SALOMON BROS

Job #6234 (7 W.T.

RE: SBI - World Trade Center

7 WORLD TRADE CENTE
SALOMON BROTHERS

PROJECT: SALOMON BROTHERS AT 7 WTC		TITLE: UNDERGROUND FUEL OIL PIPING	
PROJECT NO: 8822440.00	DATE: 11-9-89	SCALE: 1/4" = 1'-0"	DETAIL DRAWING NO: SK-FOT-1

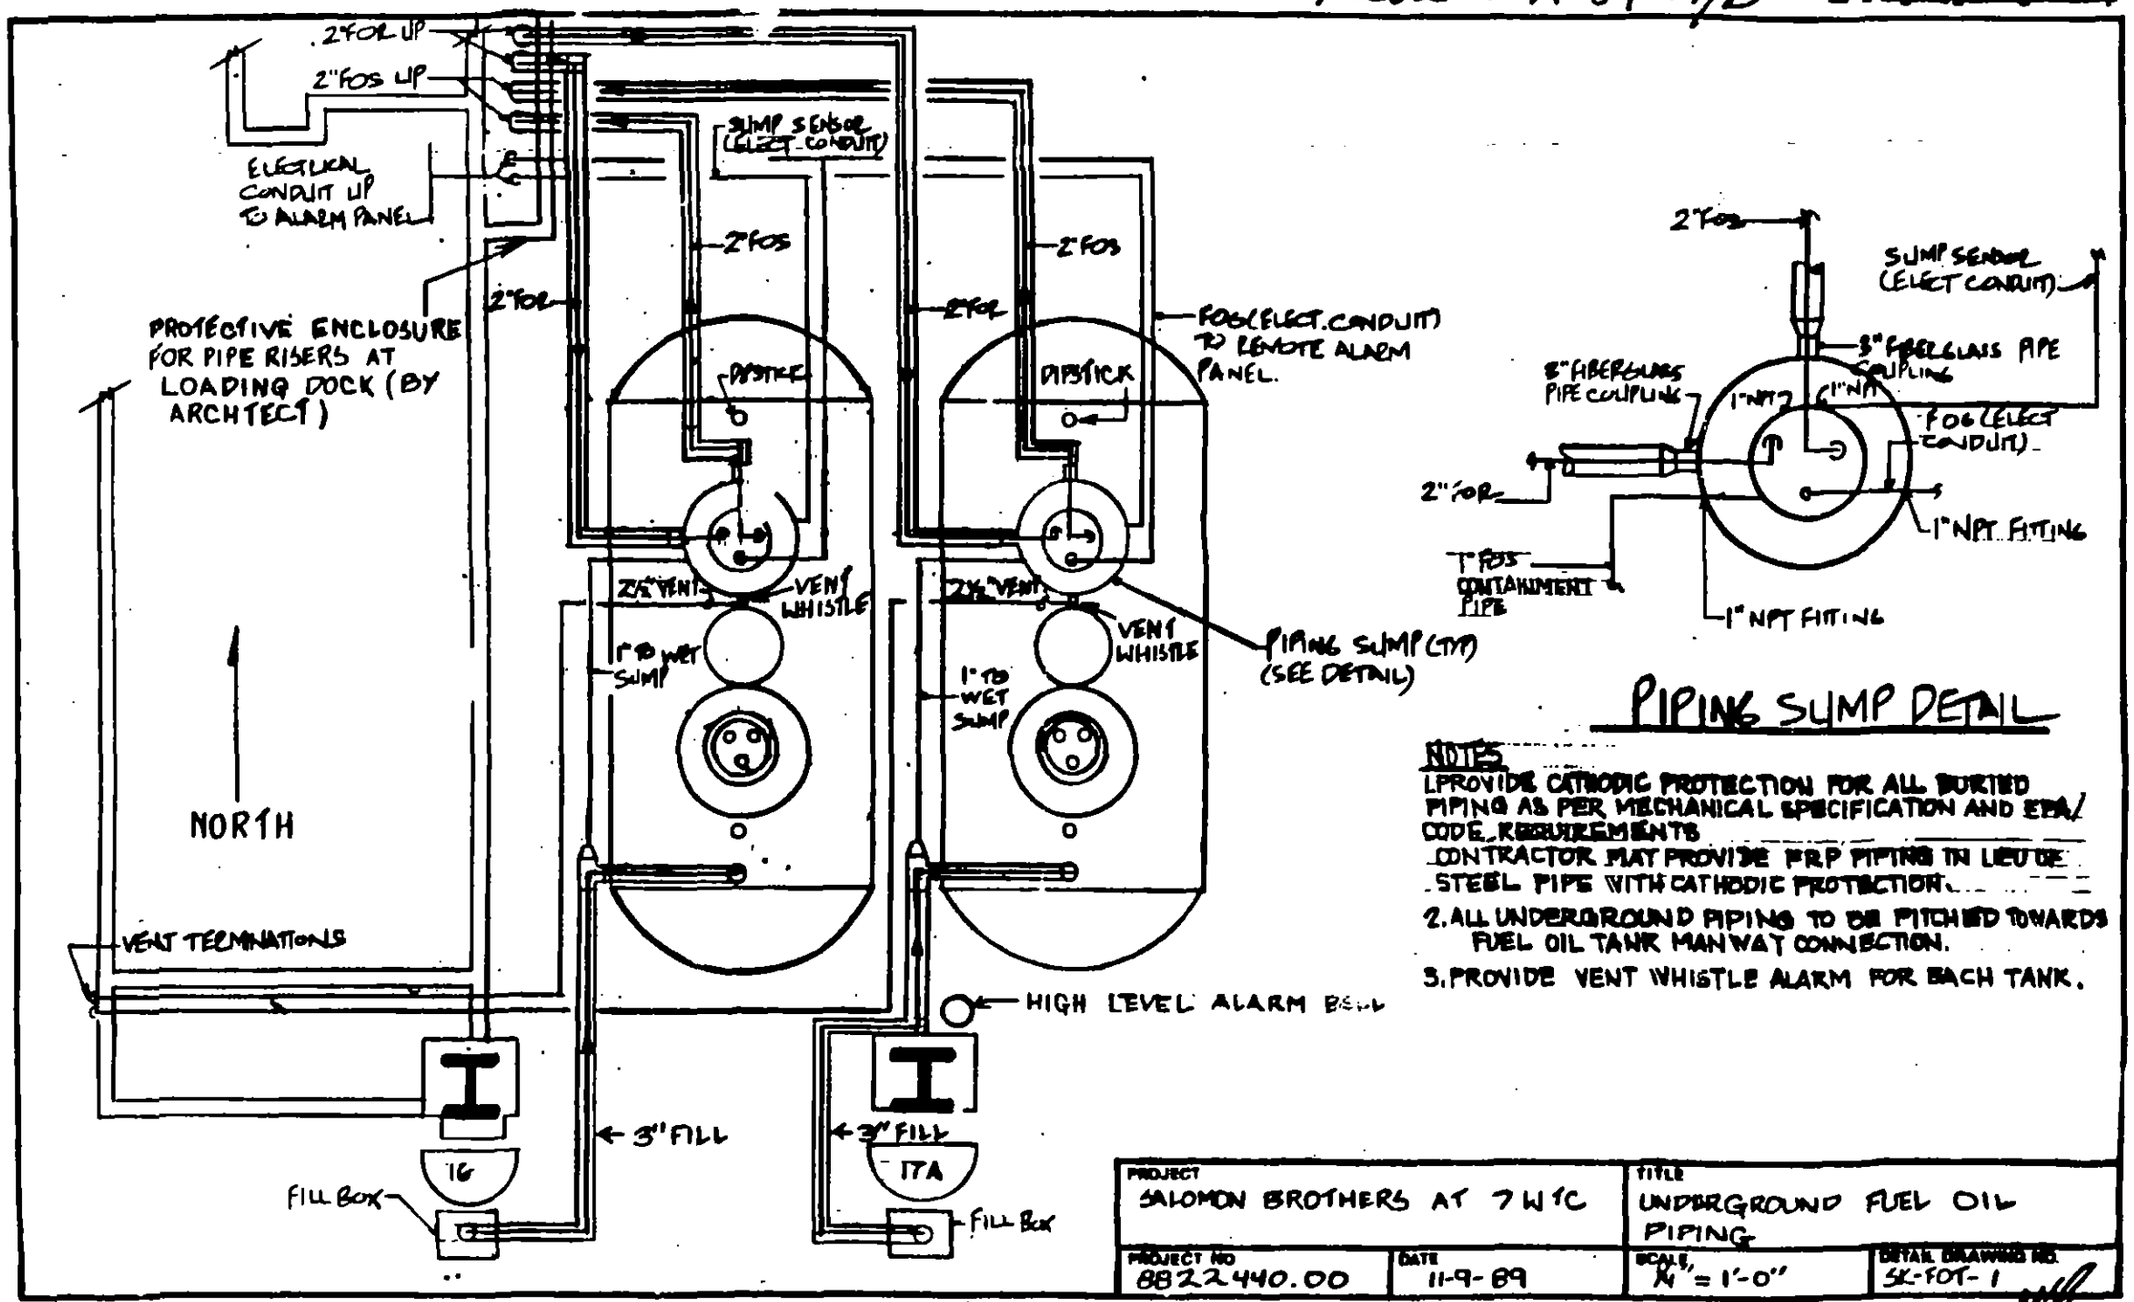
You are directed to proceed with the installation of your fuel oil piping as shown on attached Flack and Kurtz sketch SK-F02-1 Dated 11-9-89. If there are scope changes or work N.I.C. advise the writter.

Prepare a drawing detailing dimensions, pipe sizes elevations, cathodic protection etc. for approval.

This sketch supersedes the MI.1 "B" action from Flack and Kurtz.

1. PROVIDE CATHODIC PROTECTION FOR ALL BURIED PIPING AS PER MECHANICAL SPECIFICATION AND EPA/ CODE REQUIREMENTS
   CONTRACTOR MAY PROVIDE FRP PIPING IN LIEU OF STEEL PIPE WITH CATHODIC PROTECTION.
2. ALL UNDERGROUND PIPING TO BE PITCHED TOWARDS FUEL OIL TANK MANWAY CONNECTION.
3. PROVIDE VENT WHISTLE ALARM FOR EACH TANK.
